UNITED STATES PATENT AND TRADEMARK OFFICE

APPLICATION NO.	FILING DATE	FIRST NAMED INVENTOR	ATTORNEY DOCKET NO.	CONFIRMATION NO.
10/718,056	11/20/2003	Koji Yamada	4041J-000812	9293
27572	7590	08/29/2006	[REDACTED]	EXAMINER
HARNESS, DICKEY & PIERCE, P.L.C. P.O. BOX 828 BLOOMFIELD HILLS, MI 48303				FORD, JOHN K
			[REDACTED]	ART UNIT
				PAPER NUMBER
				3753

Office Action Summary	Application No.	Applicant(s)	
	10/718,056	YAMADA ET AL.	
	Examiner	Art Unit	
	John K. Ford	3753

An annotated picture of Figure 9 of this reference showing the component parts in relation to the claimed limitations is shown on the next page by way of explanation. It is submitted that this is somewhat clearer than a verbal explanation would be.

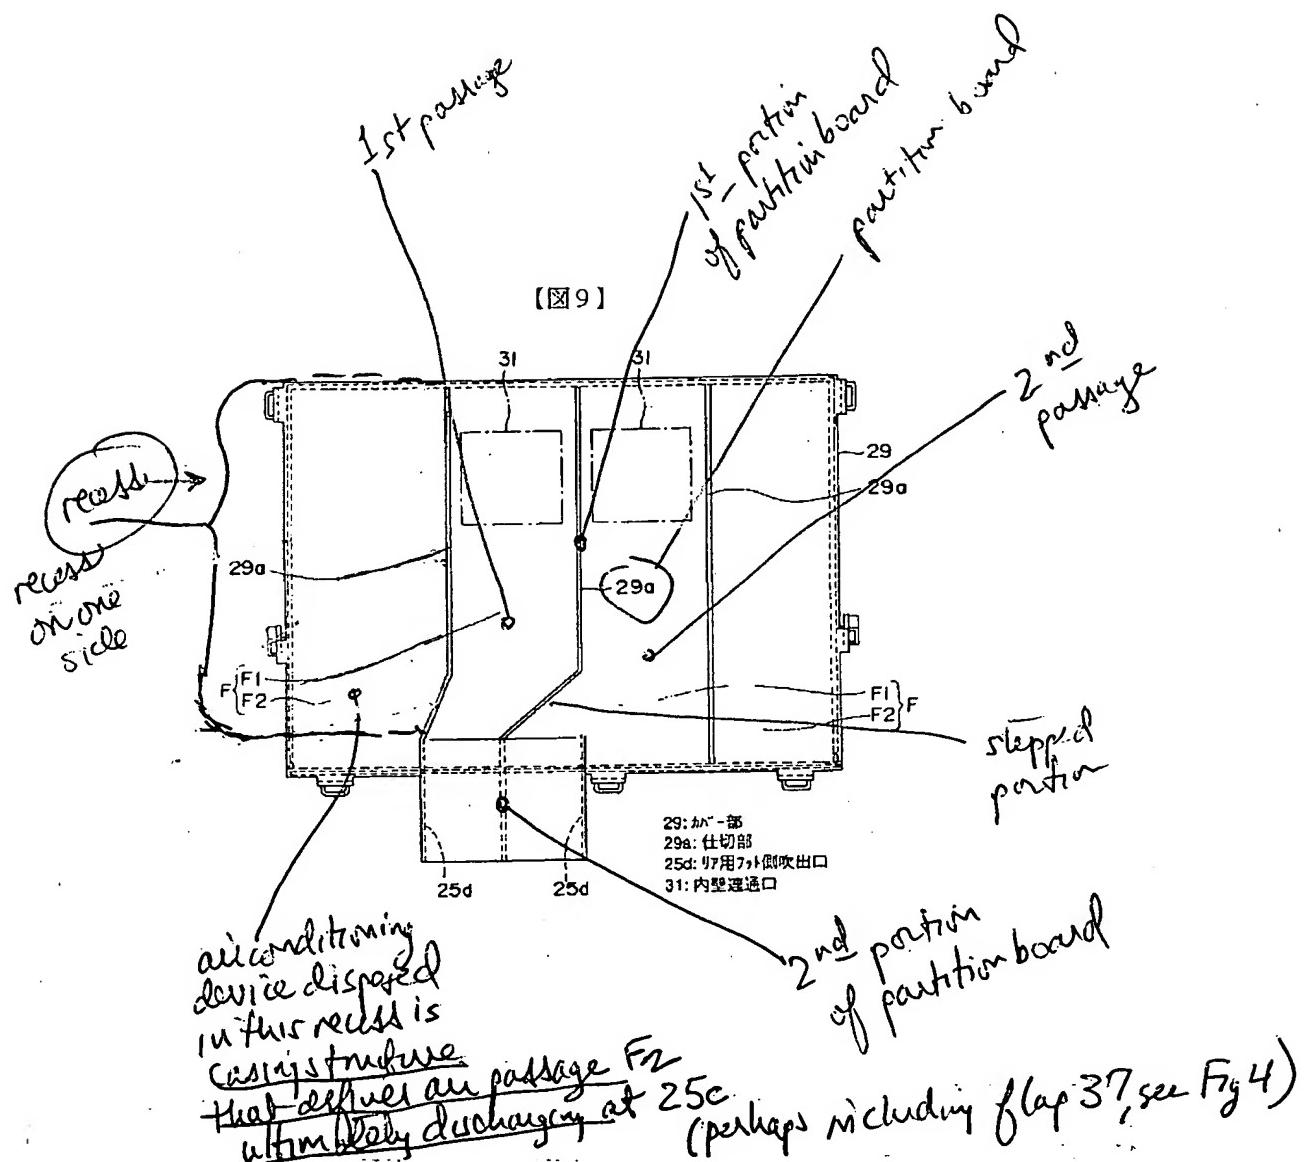
Claims 1, 10, 19, 20, 21 and 22 are rejected under 35 U.S.C. 102(b) as anticipated by or, in the alternative, under 35 U.S.C. 103(a) as obvious over JP 11-48753.
